T4F Twin Engine A-Series Relay

Notice

A7/8/9 with John Deere T4F or Cummins T4F Aux Engine

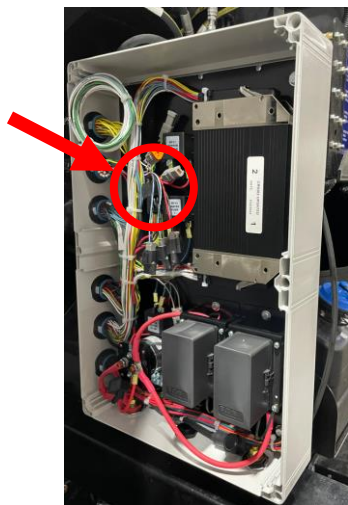
It has been discovered that Schwarze has received and installed an unknown quantity of control boxes that contain a 30 amp relay instead of the required 50 amp relay for the hydraulic cooler fan circuit. An undersized relay could fail and cause overheating of the hydraulic system.

Inspect the hydraulic cooler fan circuit in the control box to identify the relay's amperage capacity. To do this, first ensure the unit is in a safe state to work on by placing the transmission in neutral, engaging the park brake, shutting the chassis off, and placing the chassis battery disconnect switch to the "OFF" position. Remove the keys and store in a safe location so that the unit can not be turned on. Next, remove the cover on the control box and set aside. The relay for the hydraulic cooler fan should be located between the controller and bulkhead connectors on the inboard side of the control box. The correct relay is Schwarze part number 70868 (Picker P/N PC792C-1C-C-12C-N-X). Contact the Schwarze Warranty team to replace the relay with the correct 50 amp relay if a 30 amp relay is found.
